Final Environmental Impact Statement for

**Developing Home Port Facilities for
Three NIMITZ-Class Aircraft Carriers
in Support of the U.S. Pacific Fleet**

Comments and Responses for Coronado, California

**Comments and Responses for
Coronado, California
Federal, State, and Local Agencies
and Organizations**

Figure 3.18-1. Cumulative Projects in San Diego Area

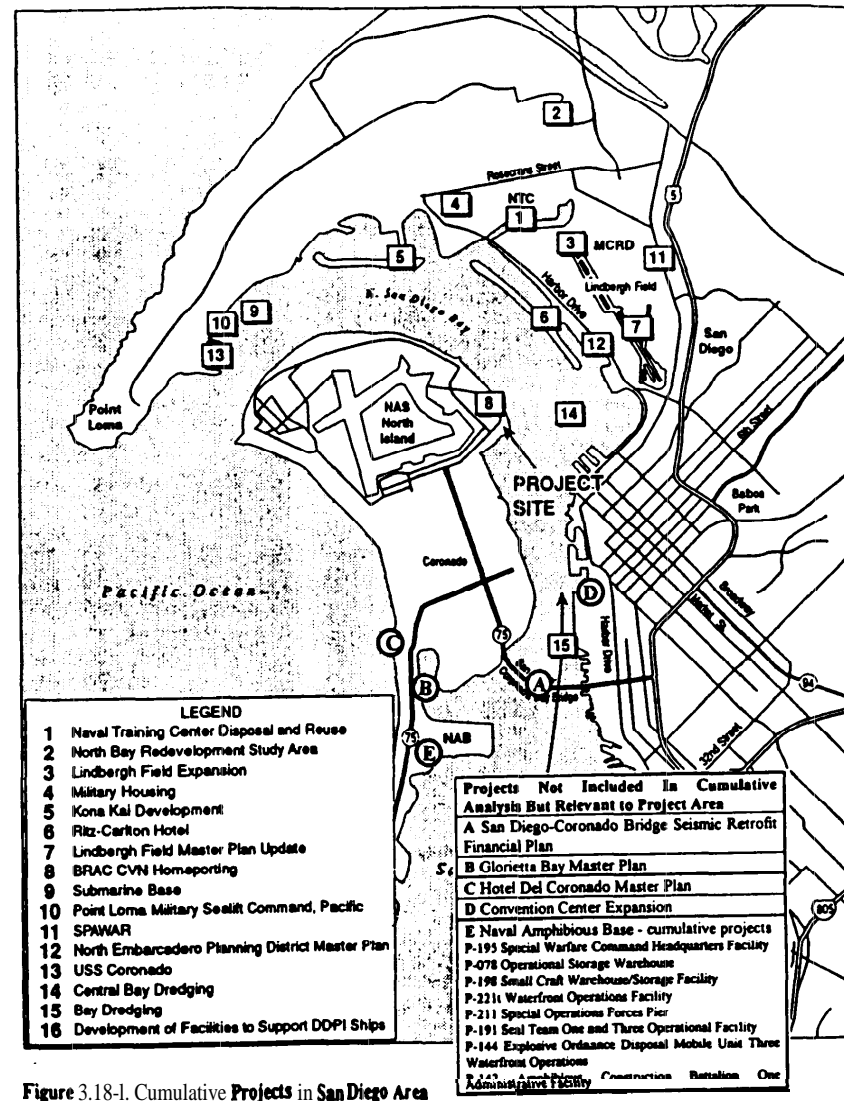
The DEIS Section 3.18 *NASNI Cumulative Impacts* Figure 3.18-1 Cumulative Projects in San Diego does not identify any past, present or foreseeable future project in or related to the transportation corridor serving the project area. In fact, there appears to be a deliberate attempt to avoid identifying such projects. Great care has been taken to identify projects as far away as Old Town and North Bay, yet large projects in and around the transportation corridor serving the project area have been excluded from cumulative analysis. Failure to consider the cumulative impacts of projects on the transportation corridor serving the project area constitutes a serious flaw in this document.
